**Bulletin No.:** 08-08-67-013C

**Subject:** Snap, Pop, Creak or Rattle Noise From Lift Off Roof Panel While Driving (Verify Condition and Perform Appropriate Repairs)

2005-2010 Chevrolet Corvette

### Condition #6

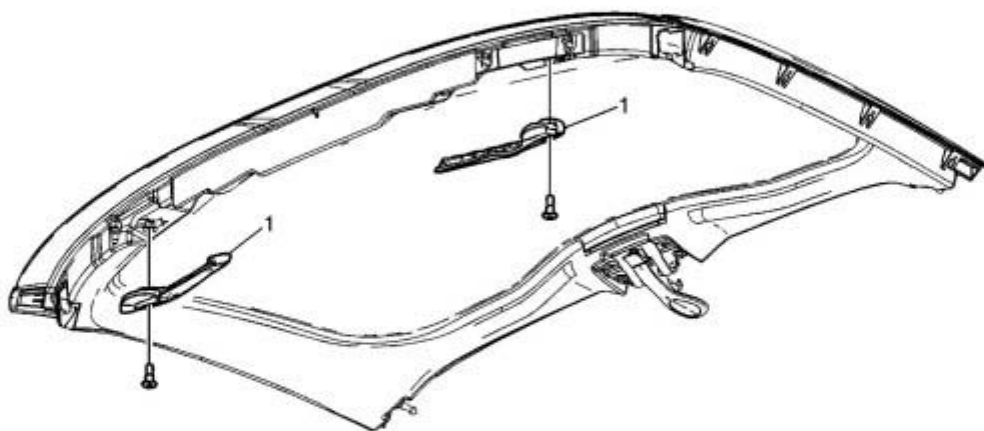
Some customers may comment of a snap, pop, creak, or rattle noise coming from the roof near the windshield, at the front latch area.

This condition may be caused by the nylon roller inside the left and/or right front roof panel latching handle becoming loose and causing the roller to move on the pin, creating the noise.

- If the roller is round and will spin on its axis (as shown above), they are early design handles and should be replaced. Replace the left and right front lift off roof panel handles with the current handle design parts noted previously, and include the lubrication steps below.

**Important:** For any latch handle replacement, use only P/Ns 19206591 (left) and 19206592 (right). These current handles have a revised roller that was redesigned so it does not roll, but now slides across the latch receiver. All 2009&hyphen;2010 removable roofs (painted and transparent) have the new handle design.

1. If the noise is verified to be coming from the front latch area, remove the latch handles (1) and inspect the handle roller. Refer to Roof Lift Off Panel Front Latch Handle Replacement in SI. Identify the design, and the resulting repair, from the two choices below:

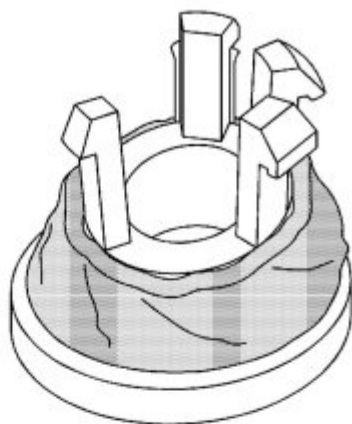
The flocking is designed to insulate the cone when roof movement occurs.

3. Also verify that the inserts have a 8 mm (0.31 in) wide wrap of flocking tape toward the top of the cone, as shown above. If the flocking tape is worn or is missing, repair following Corporate Bulletin Number 05-08-59-003E.
